PLANNING, ZONING, & BUILDING DEPARTMENT
PZ&B Staff Combination Memorandum: Architectural Commission and Town Council

SUBJECT: ARC-24-0029 (ZON-24-0023) 242 PARK AVE

MEETING: AUGUST 28, 2024 ARCOM
SEPTEMBER 11, 2024 TC

ARC-24-0029 (ZON-24-0023) 242 PARK AVE (COMBO). The applicant, Rhonda Nasser, has filed an application requesting Architectural Commission review and approval for modifications to first floor fenestration and the addition of a swimming pool, requiring variances for pool setback, pool equipment setbacks, and pool equipment screening. The Town Council shall review the application as it pertains to zoning relief/approval.

PROPOSED NORTH ELEVATION

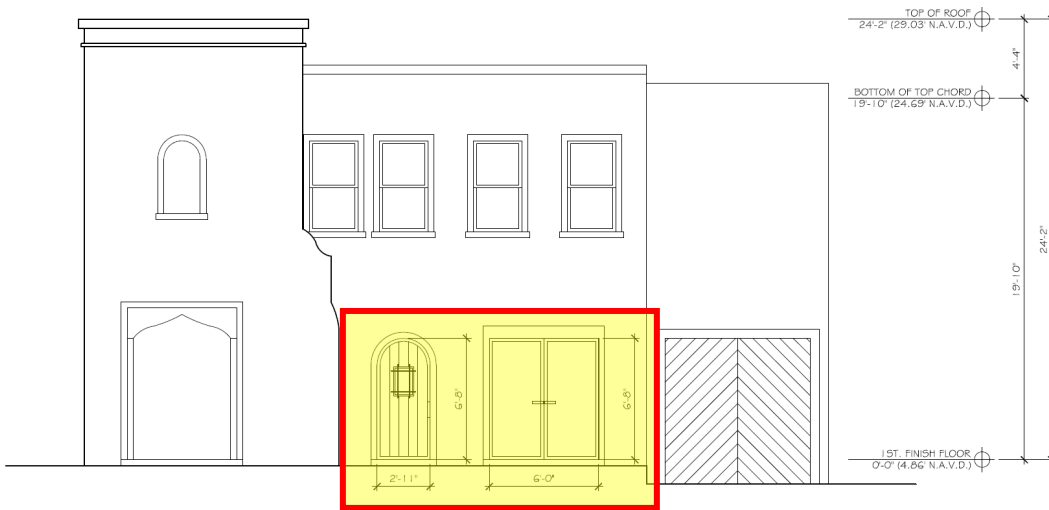
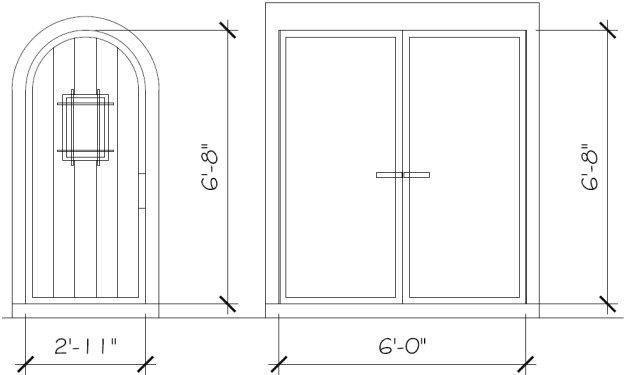
NEW PECKY CYPRESS
DOOR PROPOSED

IMPACT RATED
ALUMINUM AND GLASS
FRENCH DOORS TO MATCH
EXISTING WINDOWS
AND DOORS

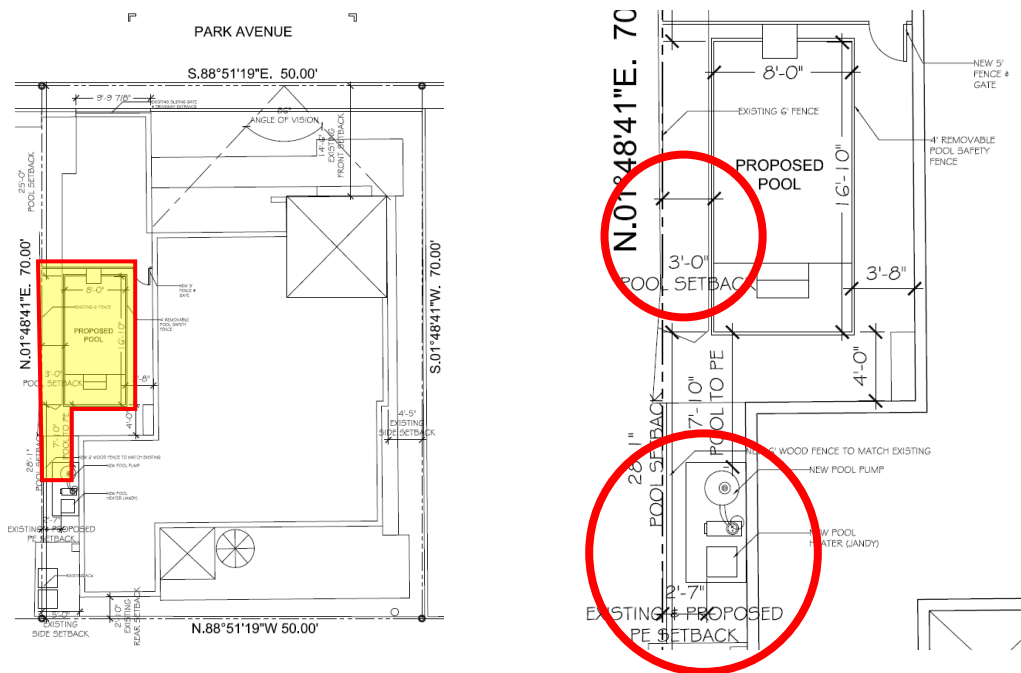
Code Section	Permitted/Required	Proposed	Variance
<u>VARIANCE 1:</u> Sec. 134-1757	Min 10' side-yard for swimming pools.	3' swimming pool side yard setback	7'
<u>VARIANCE 2:</u> Sec. 134-1728(c)(1)	Min 5' side-yard setback for swimming pool pumps and filters.	2.58' side yard setback for swimming pool pump and filter	2.42'
<u>VARIANCE 3:</u> Sec. 134-1728(c)(2):	Min 10' side-yard for swimming pool heaters.	2.58' side yard for swimming pool heaters	7.42'
<u>VARIANCE 4:</u> Sec. 134-1728(c)(7)	Screening swimming pool heaters with a concrete masonry wall as high as the equipment.	Completely forgo concrete screening wall requirement.	6' wood fence in lieu of concrete masonry wall required.
